CCEC-25-004

Christopher M. Crane Clean Energy Center
Renewed Facility License No. DPR-50
NRC Docket No. 50-289

Subject: License Amendment Request - Application to Revise Renewed Facility License and Permanently Defueled Technical Specifications to Support Resumption of Power Operations

INCORE INSTRUMENTATION SPECIFICATION
CRANE CLEAN ENERGY CENTER

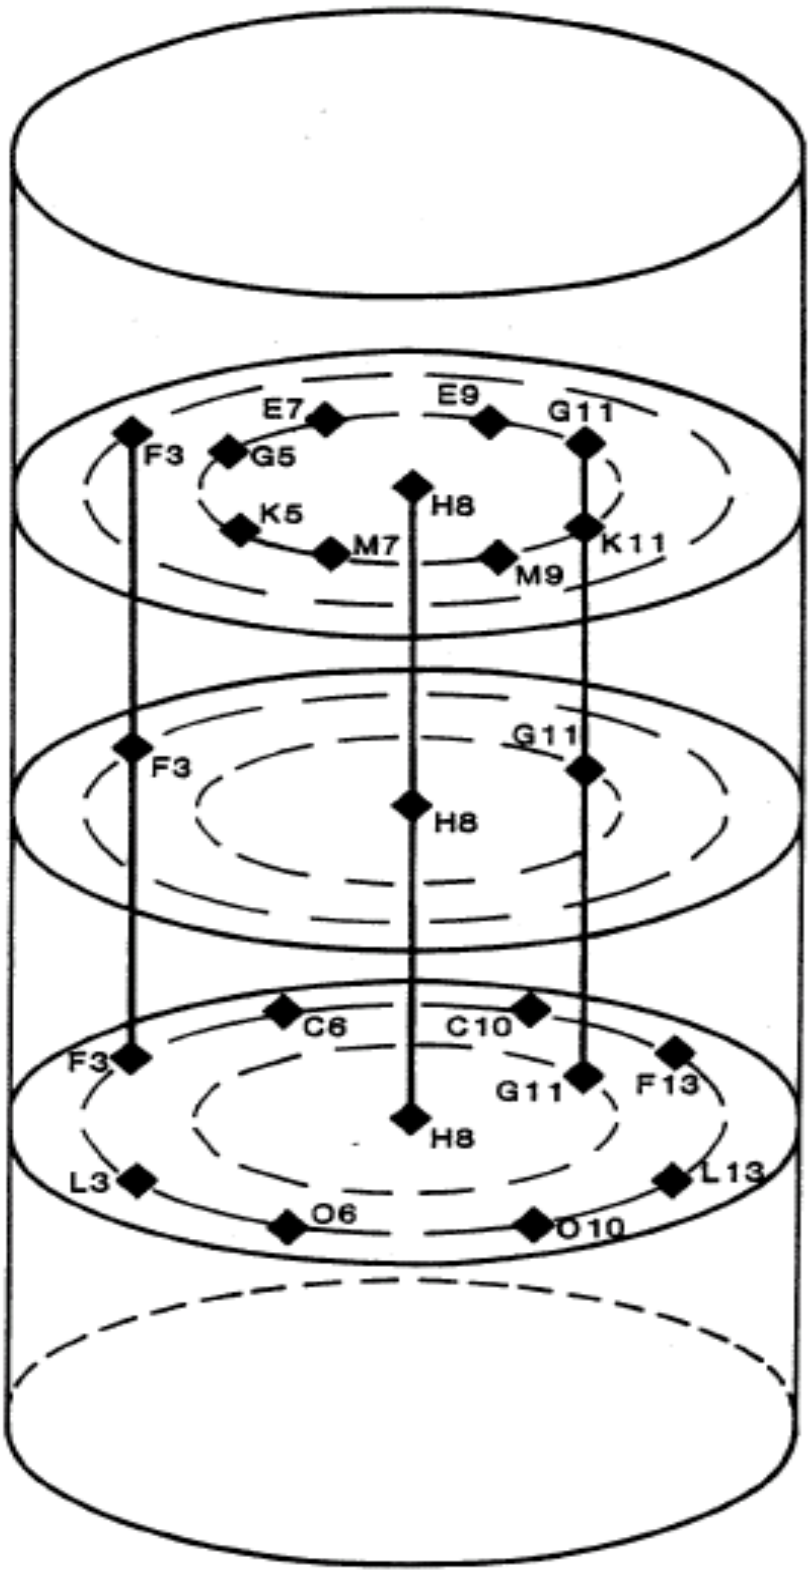
LCO 3.5.4 – Incore Instrumentation (deleted)	LCO 3.5.4, Incore Instrumentation, was previously deleted by Amendment 211 (ML003765996). Figure 3.5-1, Incore Instrumentation Specification Axial Imbalance Indication, Figure 3.5-2, Incore Instrumentation Specification Radial Flux Indication, and Figure 3.5-3, Incore Instrumentation Specification aid in determining the functionality of the full incore system for measurement of QPT and axial power imbalance specified in LCO 3.5.2. Figures 3.5-1, 3.5-2, and 3.5-3 are being reinstated in the proposed change, consistent with Amendment 294 of the TS.
LCO 3.5.5 – Accident Monitoring Instrumentation	LCO 3.5.5, Accident Monitoring Instrumentation, establishes requirements for accident monitoring and post-accident monitoring instrumentation specified in Table 3.5-2, Accident Monitoring Instruments, and Table 3.5-3, Post Accident Monitoring Instrumentation, respectively. This specification satisfies Criterion 3 of 10 CFR 50.36(c)(2)(ii).

FIGURE 3.11-1

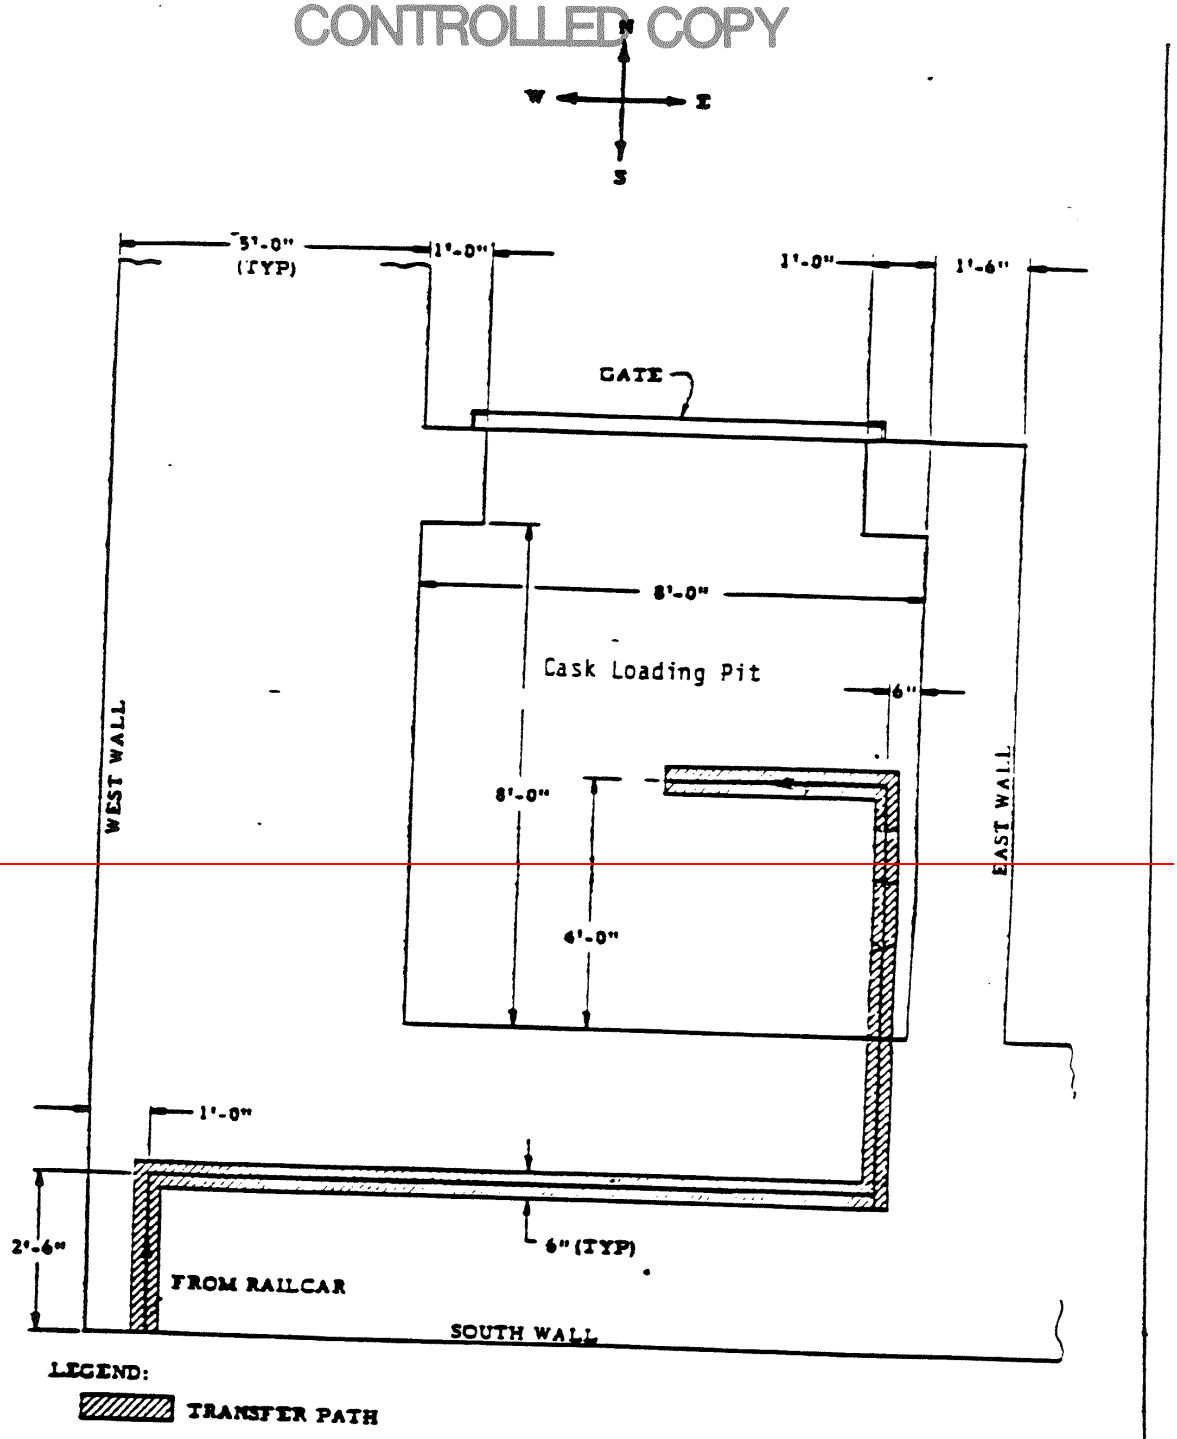
~~3.11.7 During transfer of the cask to and from the cask loading pit, the cask will be restricted to the transfer path shown in Figure 3.11-1. Administrative controls will be used to ensure that all lateral movements of the cask are performed at slow bridge and trolley speeds. During this transfer the cask lifting yoke shall be oriented in the East-West direction.~~
